**To:** Development Permit Panel  
**From:** Joe Erceg  
Manager, Development Applications  
**Date:** August 27, 2002  
**File:** DP 02-203516  
**Re:** **Application by Polygon Development 121 Ltd. for a Development Permit at 8920 Alderbridge Way**

## Staff Report

**Unit B1 (Adaptable)**

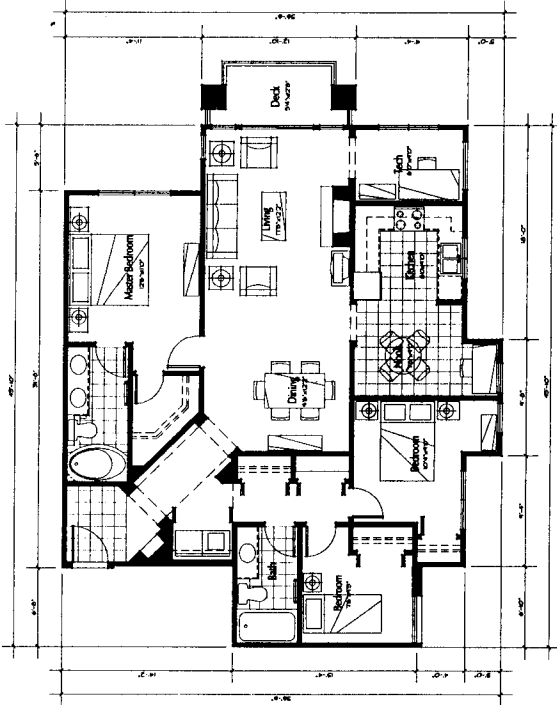
- Universal accessibility should be provided to both buildings and sites, and use of ramps and segregation of mobility-impaired and “primary” circulation/uses must be minimized. **A ramp slope of 1:20 is difficult; 1:10 is a barrier. Show how suites can be adapted for H.C. access. The ramp slopes have been improved (generally 5 to 8%). It is the developer’s policy to alter any suite for HC access upon demand (see example attached, Unit B1).**

**Show details of adaptable unit. Detail provided.**
